Access Compliance Report

Public Rights-of-Way

(Curb Ramps)

Intersection ID: 15287	Main Street: ALBEMARLE_RD	Cross Street: N_SHARON_AMITY_RD	Location: SE
ADA ID: 4478BDBD4A6E	Ramp Type: Para	Initial Pass/Fail: Pass	Overall Compliance: No
Codes/Mitigation Info/Possible Solution		Field Measurements/Component Compliance	
Severity Score: 0.25

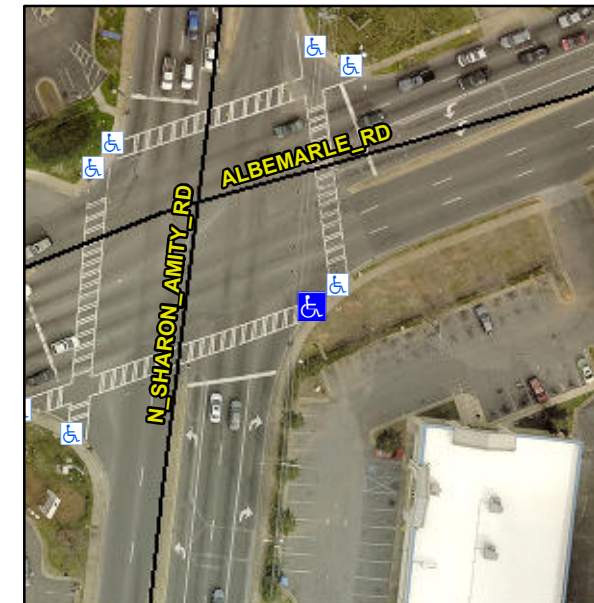
LT RP < 5%

**R304.5.3, R304.2.1, R304.2.2-Perp,
R304.3.2-Para**

Remove & Replace Entire Ramp.
